Final
Environmental Impact Report

**Newark Center
for Health Sciences & Technology**

SCH #: 2004052080

Prepared by:
Jerry Haag, Urban Planner

WELL LOCATION MAP

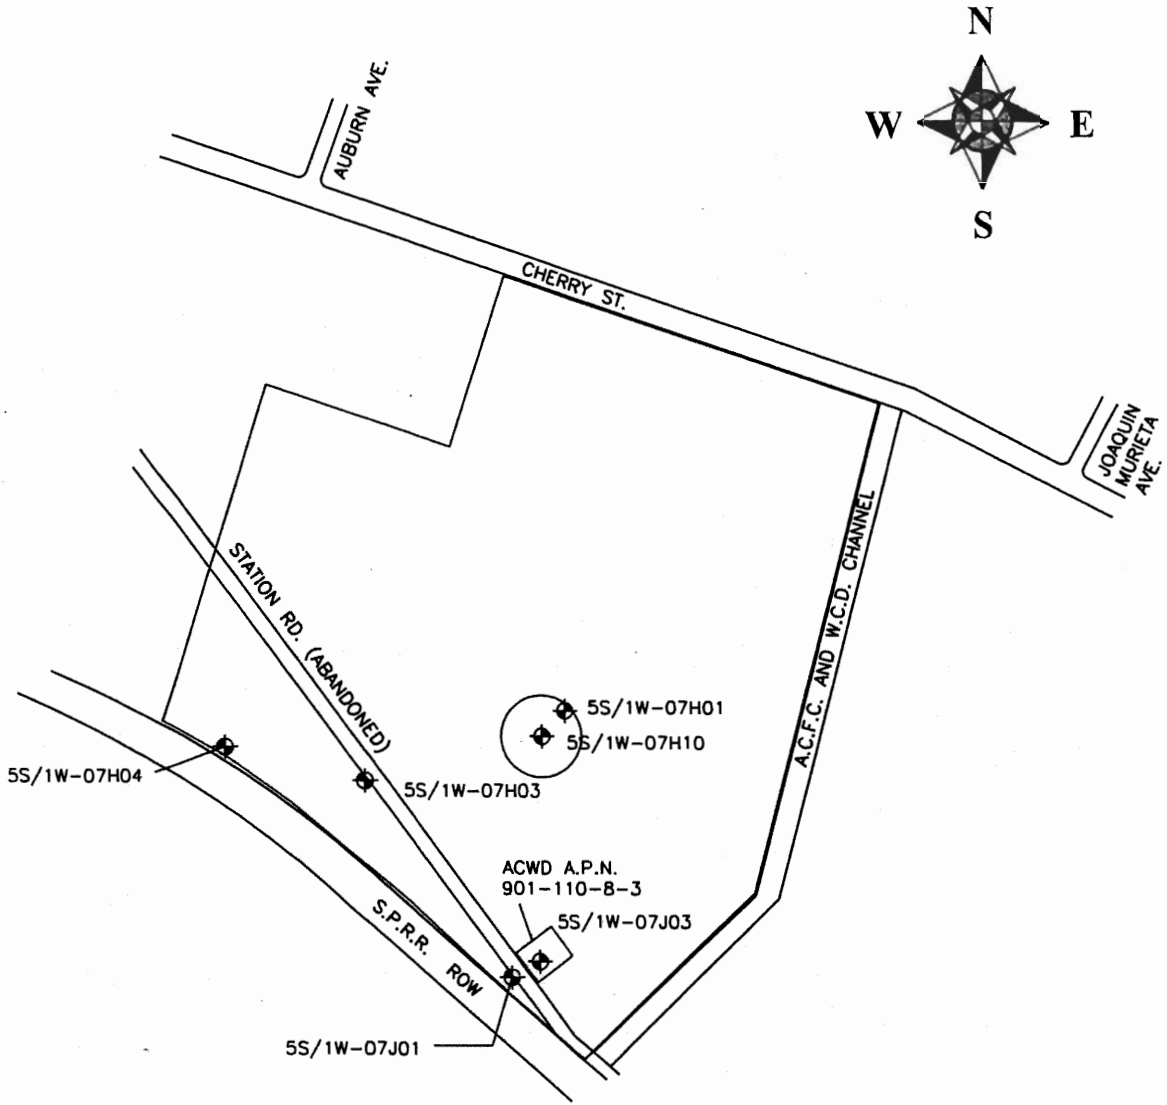
The District has determined that the following monitoring wells, as shown on the attached sketch, are located within the property boundaries of the development: **3.1.1**

- Monitoring Well No. 5S/1W-07H003**
- Monitoring Well No. 5S/1W-07H004**
- Monitoring Well No. 5S/1W-07J001**

In order to protect the ground water basin which constitutes a major source of water supply for this area, each monitoring well must either be protected or properly destroyed prior to or during development. This is the responsibility of the property owner. If the wells are to remain, a letter so indicating must be sent to the District. If the wells are: 1) no longer required by any regulatory agency; 2) no longer being monitored on a regular basis; or 3) damaged, lost, or the surface seal is jeopardized in any way during the development process, the well/wells must be destroyed in compliance with the City Well Ordinance.

Response: Comment acknowledged. The District will be notified if existing monitoring wells are to be destroyed and necessary permits will be obtained prior to any demolition.
